Model	Model Code	Year Model	Issue Date
CIVIC 5D	FK2, FK3	06	25-09-06
			Originator Product Technical/DIC Product Technical/DIC

HFT Outgoing voice clarity distorted / poor quality
This updates HUK00000000822 with new warranty information

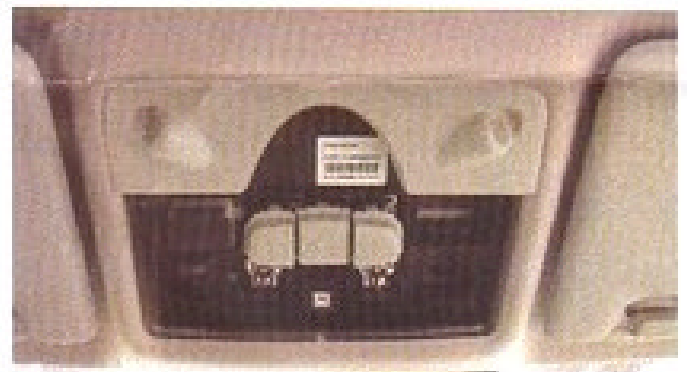
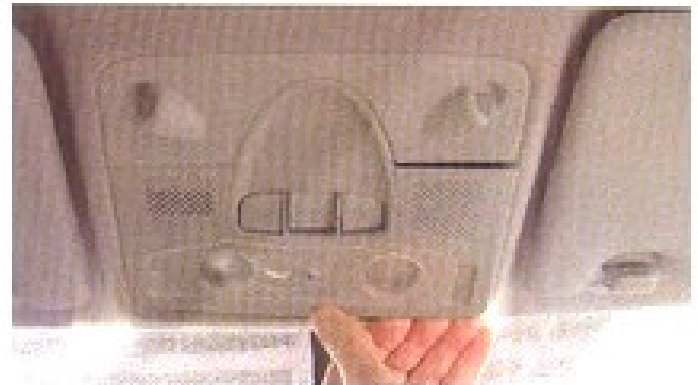
The gap between the microphone and the grille section of the interior light surround allows road noise to be amplified around the microphone housing.

Apply EPT sealer to the top of the microphone to close the gap between the interior light cover and the microphone casing.

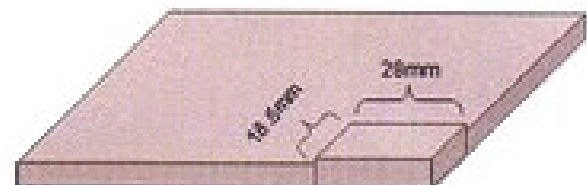
2. Using a Sharp pair of scissors cut a pelce of the EPT sealer foam to the following measurements.

Length = 28mm
Width = 18.5mm

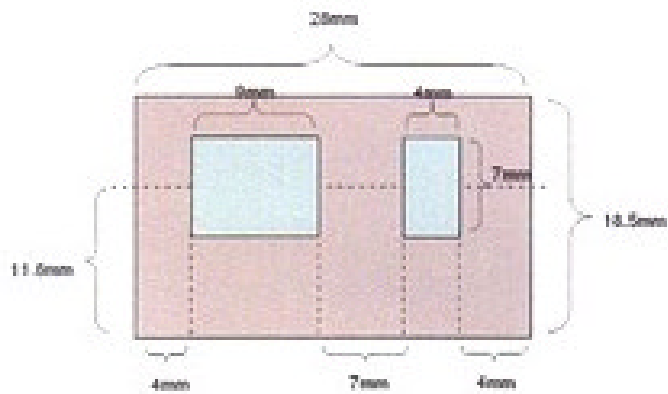
3. Once you have cut the square section of EPT sealer from the main roll of material place the square section on a flat surface and cut out the following sections shown below using a sharp knife or scalpel.

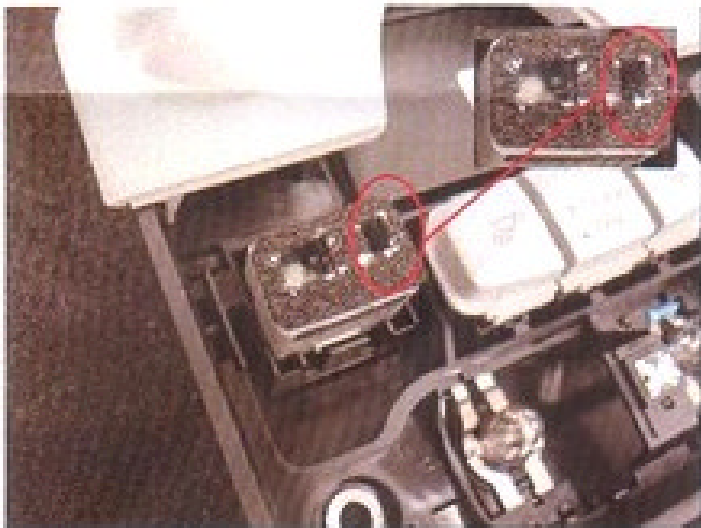
4. When you have cut out the sections from the EPT sealer place the sealer onto the top off the microphone as shown below.

Note : Do not remove the black cover on top of the microphone.

Note : Ensure the foam is applied with the correct orientation so that the smaller cut out section is placed next to the interior light switch
